Project Name: Kinkade Crossing Preliminary Plat		Project Number: LUA15-000695, ECF, MOD, PP	
Date of Hearing 11/24/15	Staff Contact Clark H. Close Senior Planner	Project Contact/Applicant Phillip Kitzes, PK Enterprises 23035 SE 263rd St, Maple Valley, WA 98038	Project Location 17709 116th Ave SE, Renton, WA 98058

ENVIRONMENTAL REVIEW COMMITTEE REPORT

Project Name: Kinkade Crossing Preliminary Plat

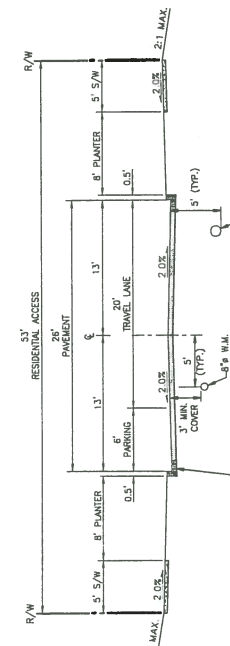
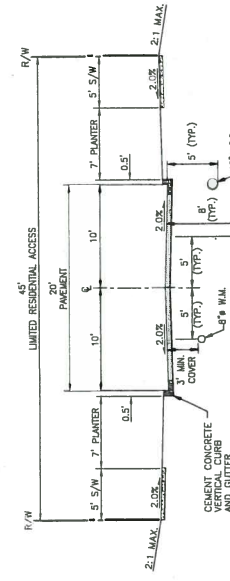
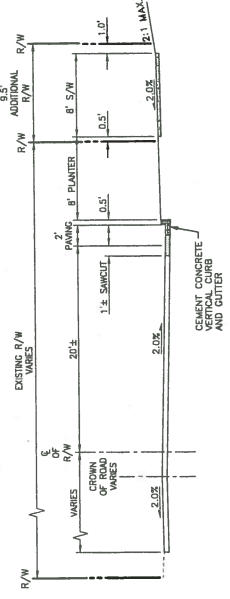
2. SE Petrovitsky Rd is a principal Arterial with existing Right of way (ROW) width of 72 feet, with 42 feet half street ROW width on the site frontage. The RMC 4 6 060 required ROW width on the 5 lane principal arterial is 103 feet, with 66 feet paved width, 0.5 feet wide curbs, 8 feet wide landscaped planters, and 8 feet wide sidewalks. As per information from Transportation section, there are plans for a separated pedestrian and bike path on the north side of SE Petrovitsky Road, which will not require bike lane paved width on the south side of SE Petrovitsky Road. Therefore, staff can support a 28 feet half street paved width along with 0.5 feet wide curb, 8 feet wide landscaped planter, 8 feet wide sidewalk, and 1 foot clear width back of the sidewalk, which will require a half street ROW width of 45.5 feet. The ROW dedication required on the project frontage based on the 45.5 feet half street ROW width is 9.5 feet, which is smaller than the RMC 4 6 060 required dedication. Therefore, a street modification request should be submitted by the developer.

3. 116th Ave SE is a minor arterial with existing ROW width varying from 60 feet to 66 feet, with 30 feet half street ROW width on the site frontage. RMC 4 6 060 has a minimum ROW width of 91 feet for Minor Arterial with 0.5 feet wide curb, 8 feet wide landscaped planter, and 8 feet wide sidewalks. Since Transportation section's plan for the street includes a half street cross section that includes a 22 feet paved width (including 5 feet wide bike lane) from center line of the ROW, 0.5 feet wide curb, 8 foot wide planter, 8 feet wide sidewalk and 1 foot clear space back of sidewalk. If the required street frontage improvements, including the 1 foot clear space can be included in the 9.5 feet of ROW dedication then the proposed ROW dedication of 9.5 feet is acceptable. However, if the required street frontage improvements, including the 1.0 foot clear space needs more than 9.5 feet of ROW dedication, then the ROW dedication greater than 9.5 feet would be required to make sure that the 1 foot clear space back of sidewalk is also within the ROW. Staff can support a street modification that would meet the plan of the Transportation section. A street modification request should be submitted by the developer.

4. South 177th Place is a residential street. The east west extension of SE 177th Place from the existing dead end located at the west of the site, to connect with 116th Ave SE is proposed to meet the east west site access requirements. To meet the city code requirements, a 53 feet wide ROW width with 26 feet wide paved width with 0.5 feet wide curbs, 8 feet wide landscaped planters, and 5 feet wide sidewalks are required.

5. A limited access residential street with 20 feet paved width, with hammerheads at the north end or south end, is proposed as the internal north south site access. 0.5 feet wide curb, 7 feet wide landscaped planter (modification request should be submitted for reducing the 8 feet landscaped planter width), and 5 feet wide sidewalk are also shown on both sides of the street. The proposed ROW width for the limited access residential street is 45 feet. The hammer head turnaround should meet with fire department requirements also. Parking is not allowed on streets with 20 feet or less paved width. No Parking signs will be required to be provided by the developer. The site does not gain direct access from SE Petrovitsky Road. A private access tract is proposed to provide shared driveway access to Lots 4, 5, and 6. RMC 4 6 060 says that the shared driveway should not be created by a subdivision of 10 or more lots. This project is a subdivision of 17 lots. The applicant had submitted a modification request for the shared driveway, which cannot be supported by staff. Therefore, the shared driveway is not appropriate. Either extend the limited access residential street further to the south, so that all lots gain access directly from the public street, or any other access option that follows the code should be proposed. Alley access as per code requirements should be
